**Subject: Beaver Valley Power Station, Unit Nos. 1 and 2
BV-1 Docket No. 50-334, License No. DPR-66
BV-2 Docket No. 50-412, License No. NPF-73
Responses to a Request for Additional Information (RAI dated
September 30, 2005) in Support of License Amendment Request Nos.
302 and 173**

Non-Proprietary Responses to RAIs dated September 30, 2005

BEAVER VALLEY POWER STATION, UNIT NOS. 1 AND 2 (BVPS-1 AND 2)

EXTENDED POWER UPRATE (EPU)

Figure E.6-1 BVPS-2 2-Inch PCT Response

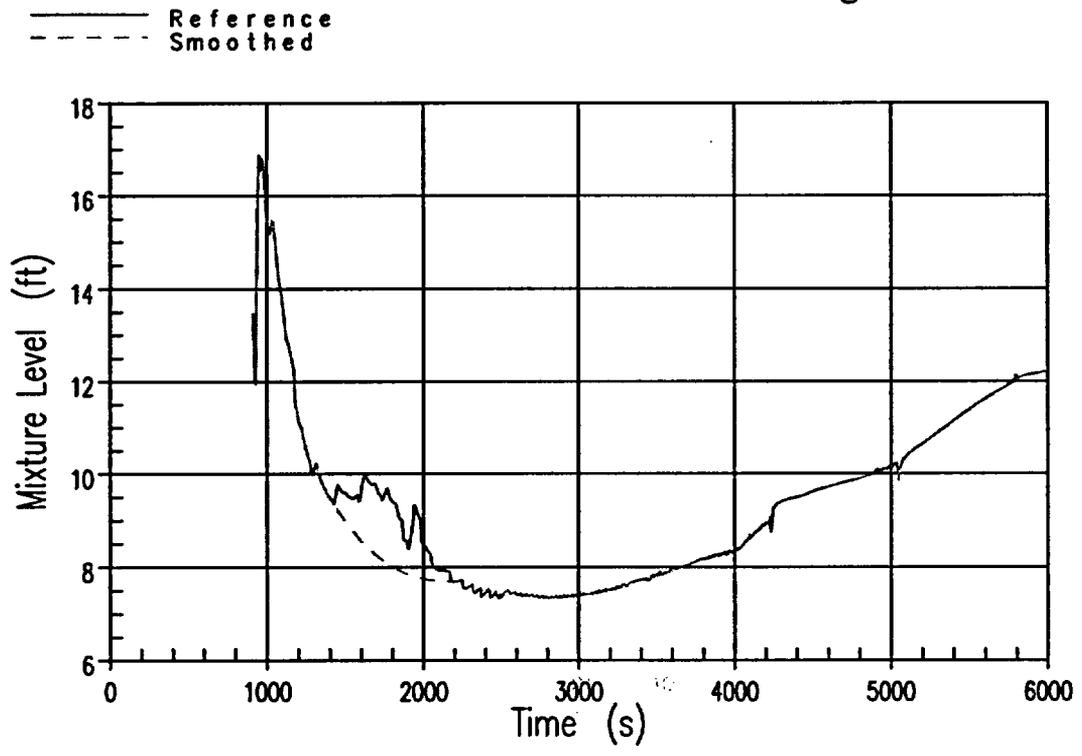
As shown in Figure (Fig.) E.6-7, removing the erratic behavior in the two-phase level between 1400 and 2200 sec shows elimination of the cooling between 1400 and 1800 sec. However, since the minimum level is not turned around until about 3200 sec, what caused the cooling between 2200 and 2400 sec? It appears that the PCT should be increased by the difference in temperatures at around 2200 sec. Please explain.

The figure in question is shown in Figure E.6-1. The following information is provided to supplement the response.

Since the core cooling boundary conditions, as passed from the NOTRUMP Thermal & Hydraulic (T&H) code, are identical beyond the 2200 second time period, the code will naturally attempt to re-converge on cladding temperature given that no cladding rupture was predicted to occur. In addition, the cladding temperatures which occur during this time frame are below the sensitive metal water reaction range (i.e. $> 1700^{\circ}\text{F}$). As a result, the cladding temperatures will re-converge given the same T&H boundary. Since the cladding temperatures at ~2200 seconds are different between the reference and smoothed mixture level case, there will be a time period over which they will re-converge once the same boundary conditions are re-established (Figure E.6-3). Figure E.6-4 shows that the cladding heat flux for the smoothed mixture level case is higher than for the reference case. This is a direct result of the elevated cladding temperature at the time where identical boundary conditions were re-established. Subsequently, more heat is released from the cladding to the steam over this time period which slows the cladding temperature increase while the two cases re-converge. This re-convergence period takes approximately 300 seconds to occur and is essentially completed at approximately 2500 seconds. Had cladding rupture or PCTs above 1700°F occurred during the period of interest, the cladding temperatures may not have re-converged due to blockage and metal-water reaction rate affects.

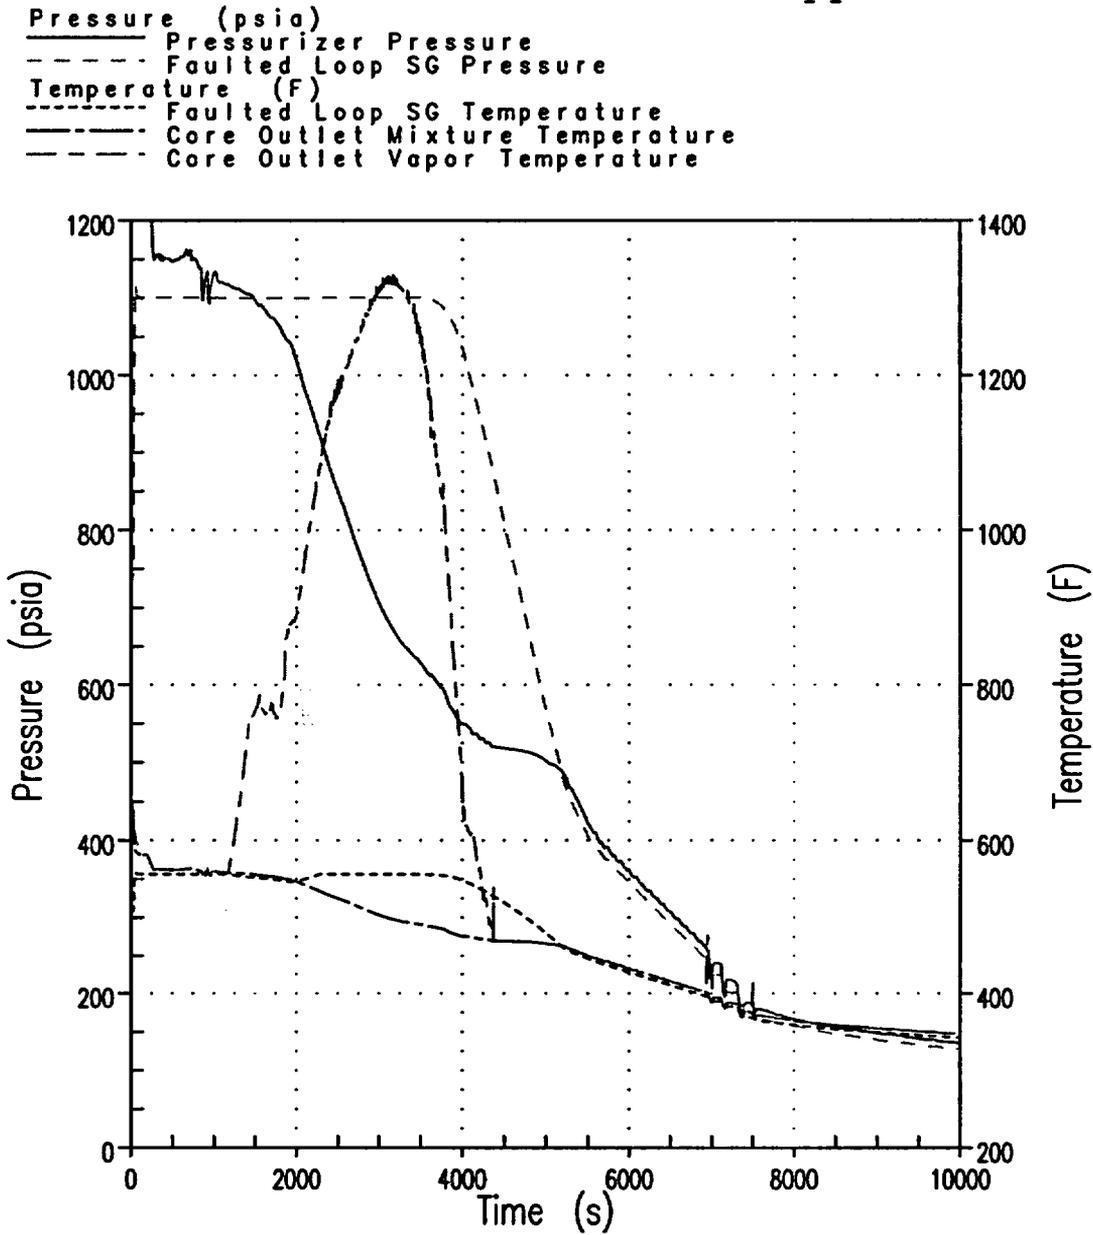
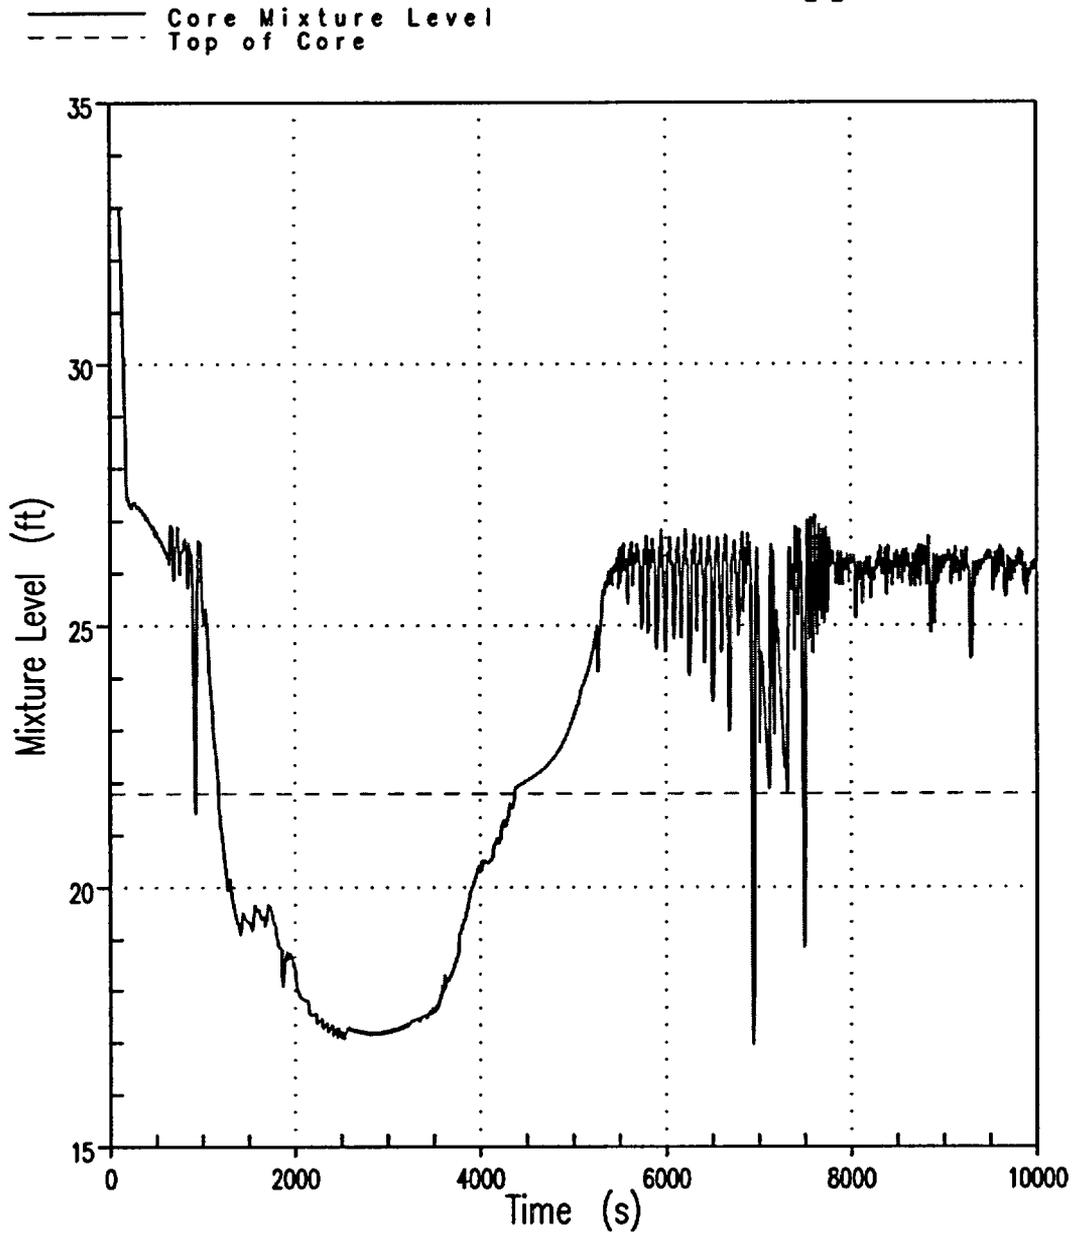
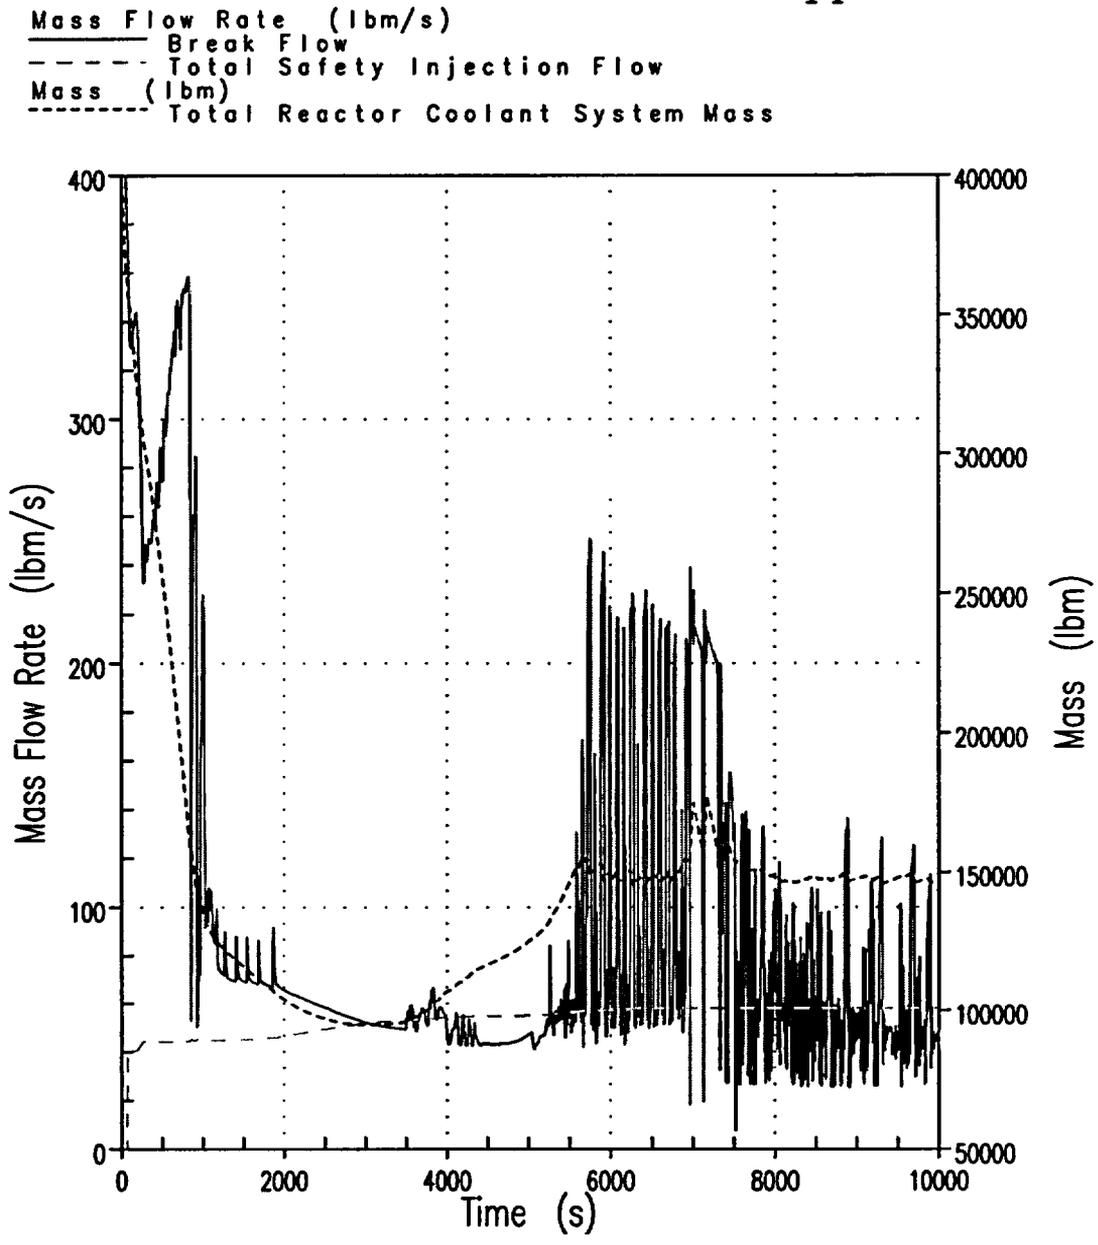
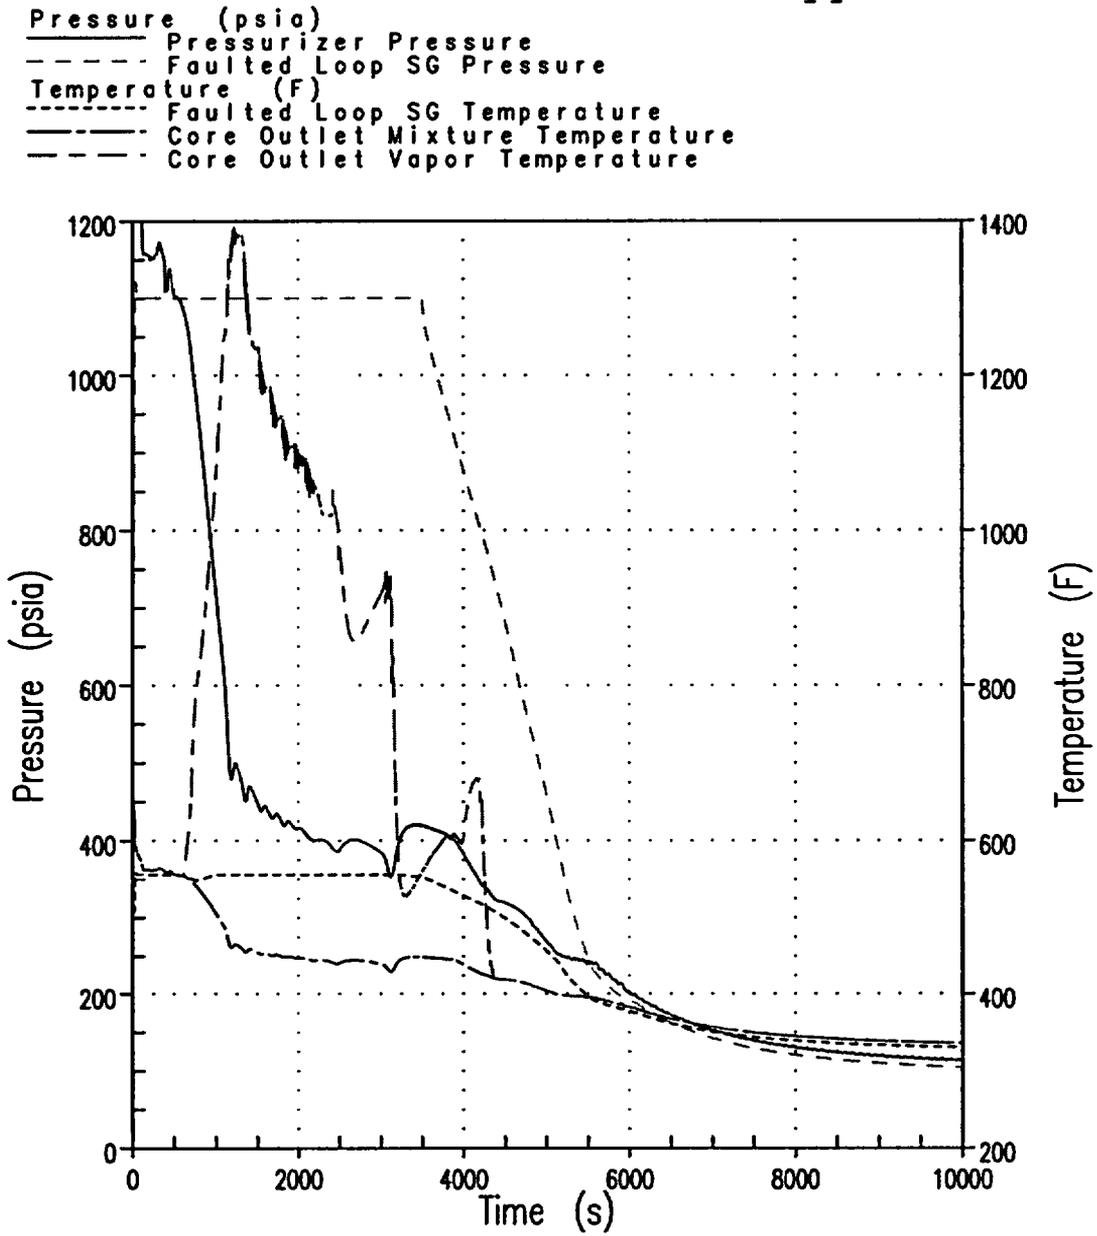
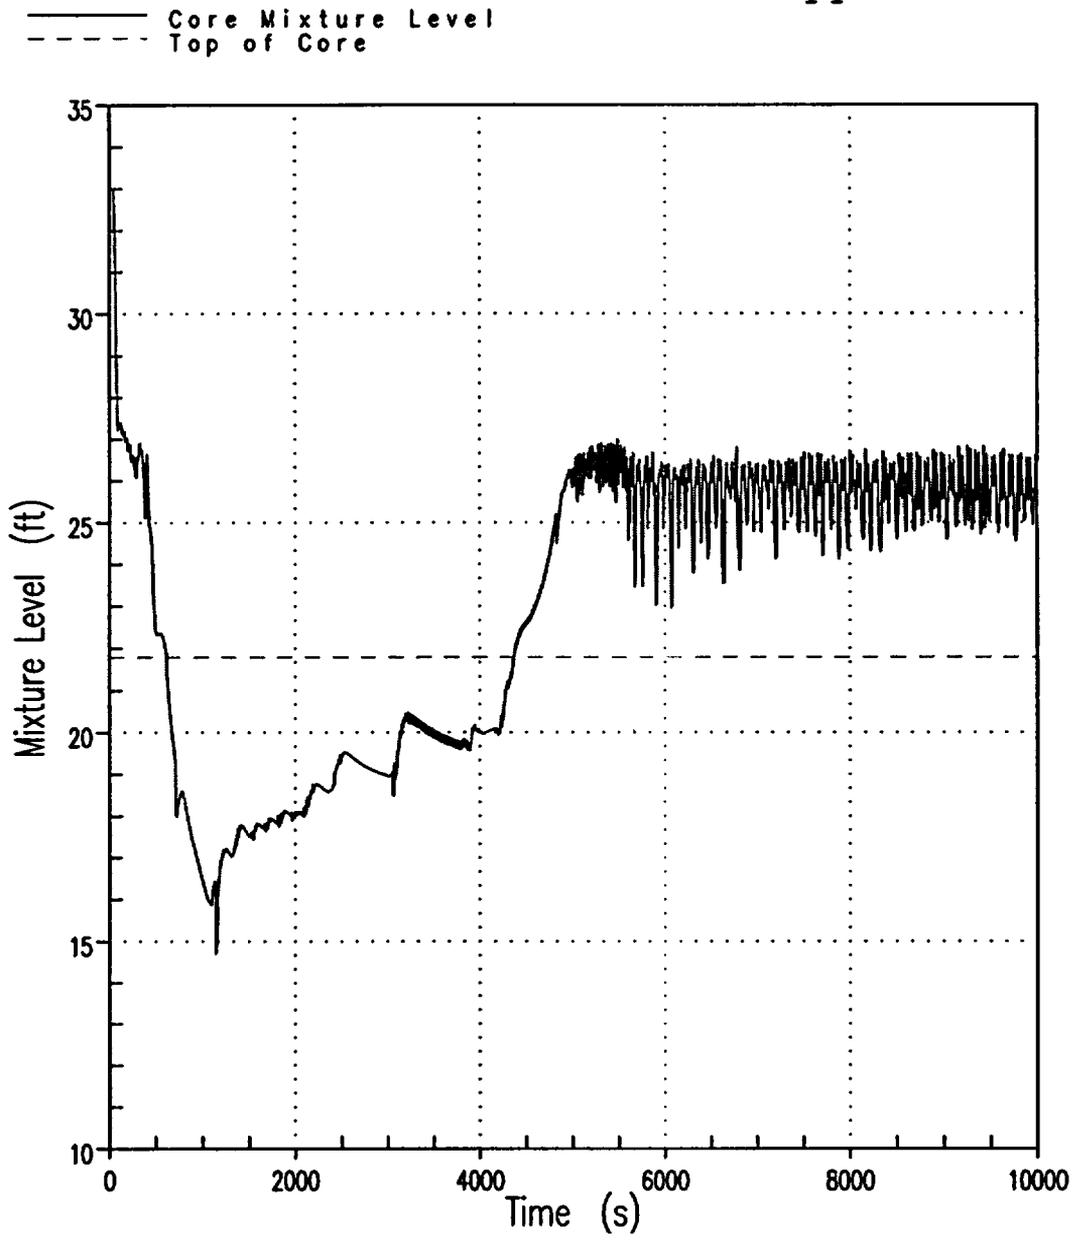
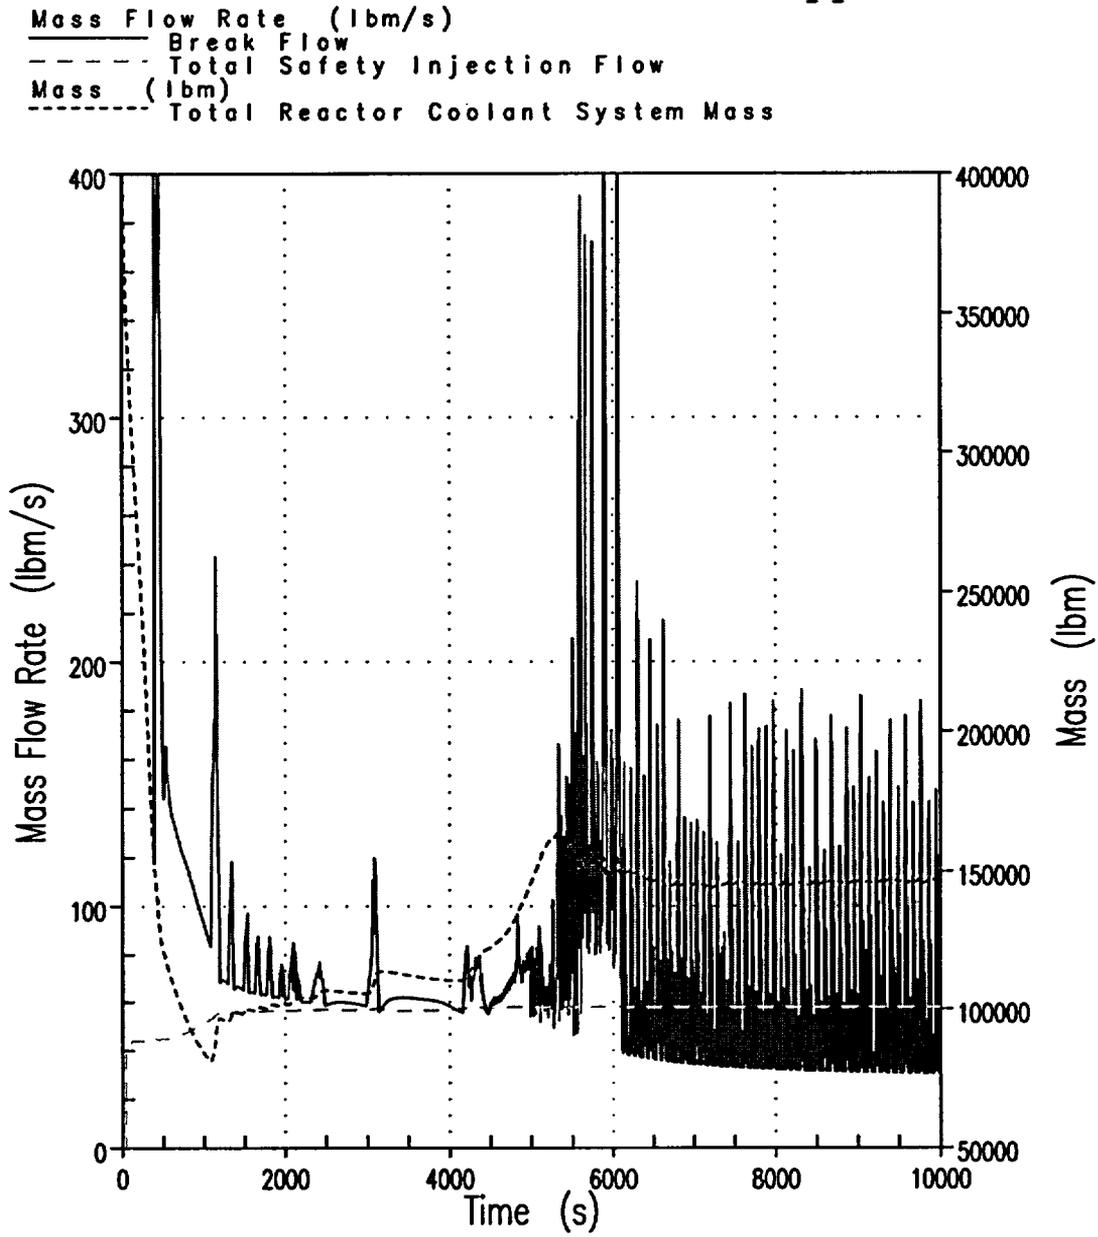
For the 3-inch break, the top portion of the core has not been recovered and in fact the two-phase level is decreasing at 5000 sec. in Fig. E.8-5. If operator action is required to cool the core for small breaks during the short term, please identify the actions and show that the core can be recovered so that the core is quenched and oxidation is no longer relevant. Identify what actions are required and show the effect on PCT and oxidation. Identify the timing for operator actions and demonstrate that the latest time for action is reflected in the EOPs. What is the latest time allowed for the recommended operator actions? Also, since the two-phase level is below the top of the core at 5000 sec for the 3-inch break, RHR cannot be operated since the loops contain steam (re-establishment of single phase natural circulation by refilling the RCS with ECC liquid is expected to take a long time). Since RCS pressure is already low for the 3- and 4-inch breaks, depressurization with SGs and PORVs may not be timely nor effective. Please show the analyses that are required to show the core is quenched and oxidation is no longer increasing.

The significant operator action steps would be to cool the RCS down by dumping steam either from the steam generators (SG's) through the steam dump system or the atmospheric relief valves. This would be done at a rate not to exceed 100°F/hr to prevent pressurized thermal shock concerns. There is no upper time limit as to when an operator action must occur in this regard. As stated above, there is nothing in the simulation results or the plant conditions at later times to indicate that core temperatures would deviate from the near saturation conditions that exists in the longer term (i.e. post PCT and oxidation cessation) until full level recovery is achieved. [

It is true that for breaks of this size range (greater than ~ 1 inch), normal RHR operation cannot be used. The volumetric flow out of the break is too large to permit refilling of the RCS to the point where RCS subcooling could be re-established and allow this to occur. Long term cooling would be in the form of emergency core cooling system (ECCS) sump recirculation. The fact that vapor exists in the RCS has little impact on this. Depressurization using the steam generators is effective because of the significant heat transfer area that is available. Figures E.9-1 through E.9-9 show cooldown behavior for three different break sizes i.e. 2, 3 and 4 inch equivalent diameter. In all of these simulations, a plant cooldown was started at approximately 1 hour into the transient. This time frame includes 4 minutes of EOP transition briefings by the operating crew (i.e. E.0 to E.1 and E.1 to ES-1.2). This is well in excess of what actually occurs. Plant simulator runs executed at BVPS showed that the maximum time elapsed before plant cooldown was initiated was less than 1 hour. Included in this time period were the operator briefings conducted prior to transitioning between EOPs. The attached results are based on BVPS-2, however, they are indicative of BVPS-1 (and typical of all SBLOCA's under the same circumstances) as well since there are no differences between the units that would significantly impact these results. As can be seen, in all of these cases, depressurization of the RCS using the SG's is effective. Note that low pressure safety injection (LPSI) system flows were not included in the runs that characterized the cooldown process. If included, these would provide additional flow into the vessel as part of the long term cooling phase.

Figure E.11-1 BVPS-1 0.5-ft² Break, RCS Pressure Response

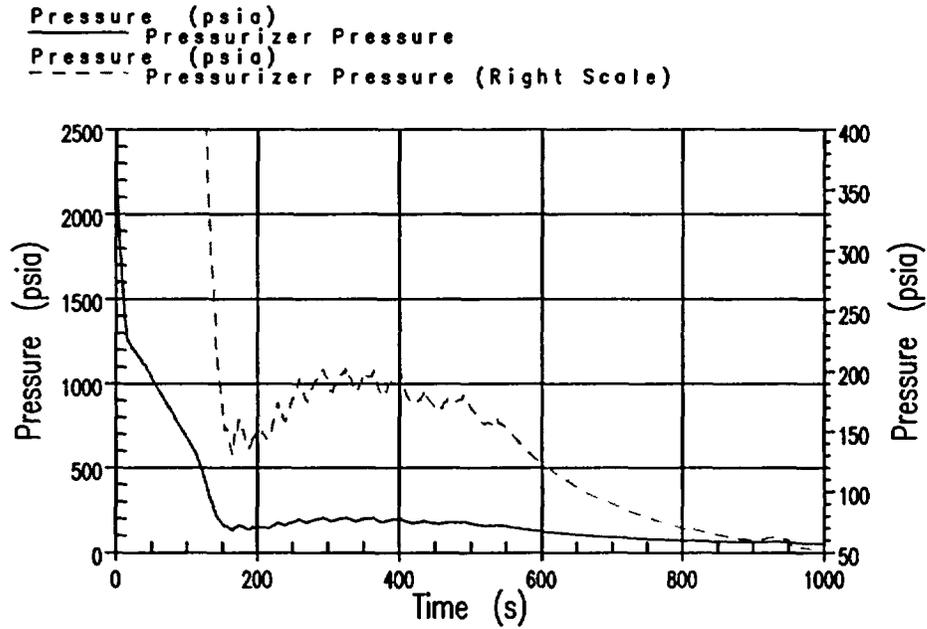
For some plants, analyses of small breaks in the 0.5 ft² to 1.0 ft² range can show these breaks to be limiting since the core totally uncovers. While the duration of the uncover is shorter for these larger small breaks, the PCT is dependent on the accumulator design to prevent temperatures from exceeding 2200°F. Please confirm, based on BVPS-1 and 2-specific conditions, that the NOTRUMP code produces less limiting PCTs for breaks 0.5 to 1.0 ft² compared to the limiting breaks controlled by HHSI (0.02 - 0.04 ft²).

Figure E.11-1 through Figure E.11-6 presents the results of the 0.5-ft² break simulation for BVPS-1. Figure E.11-1 demonstrates the rapid depressurization characteristics for breaks in this size range. As can be seen, the RCS pressure drops rapidly to the accumulator actuation set-point (625 psia) in about 100 seconds. This is evident in Figure E.11-5 which shows the RCS inventory recovery observed beginning at that time. The core/upper plenum mixture level response for this simulation is presented in Figure E.11-2. As seen, no significant sustained uncover is predicted for this simulation.
